# Access Compliance Report

## Public Rights-of-Way

Intersection ID: 15189	Main Street: DUNN_AV	Cross Street: ALPHA_ST	Location: SE
ADA ID: BB74939B2D0C	Ramp Type: PerpDiag	Initial Pass/Fail: Fail	Overall Compliance: No
Severity Score: 8.75			
Codes/Mitigation Info/Possible Solution		Field Measurements/Component Compliance

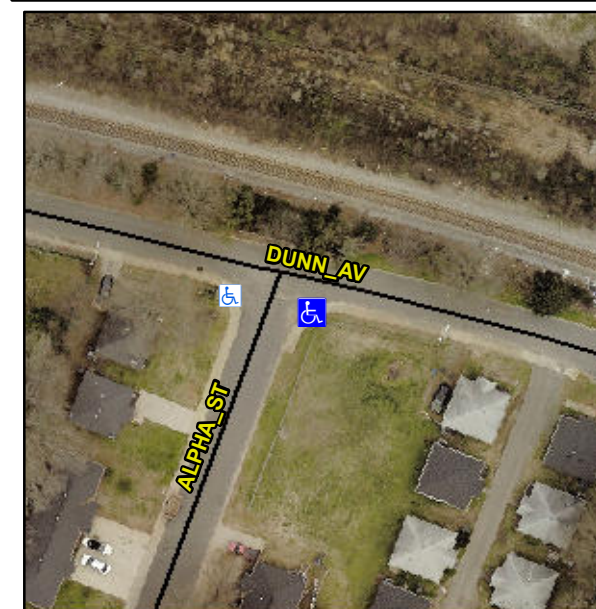
**R304.5.1**

Compliance	Description	Data	Compliance	Description	Data
N/A	Ramp Length (in)	59.0	Yes	Ramp Slope (%)	5.4
No	Ramp Width (in)	38.0	Yes	Ramp XSlope (%)	0.3
N/A	Flare Type LT	N/A	N/A	Flare Type RT	N/A
N/A	Flare Slope LT (%)	N/A	N/A	Flare Slope RT (%)	N/A
N/A	Flare Traversable LT?	N/A	N/A	Flare Traversable RT?	N/A
N/A	Landing Length (in)	N/A	N/A	DWS Provided?	N/A
N/A	Landing Width (in)	N/A	N/A	DWS Contrast?	N/A
N/A	Landing Slope (%)	N/A	N/A	DWS Length (in)	N/A
N/A	Landing X Slope (%)	N/A	N/A	DWS Full Width?	N/A
N/A	Landing Curb? (Y/N)	N/A	N/A	DWS Offset (in)	N/A
N/A	Shared Landing?	N/A			
N/A	Gutter Ponding?	N/A	N/A	Gutter Slope (%)	N/A
N/A	Gutter Lip Ht (in)	N/A	N/A	Gutter X Slope (%)	N/A
N/A	Painted X Walk1?	No	N/A	Painted X Walk2?	No
	X Walk 1 Direction	To NE		X Walk 2 Direction	To NW
N/A	X Walk 1 Width (in)	N/A	N/A	X Walk 2 Width (in)	N/A
	X Walk 1 Slope (%)	3.9		X Walk 2 Slope (%)	1.0
	X Walk 1 X Slope (%)	1.5		X Walk 2 X Slope (%)	2.8

**Remove & Replace Curb Ramp With Two New Directional Ramps or Equivalent.**
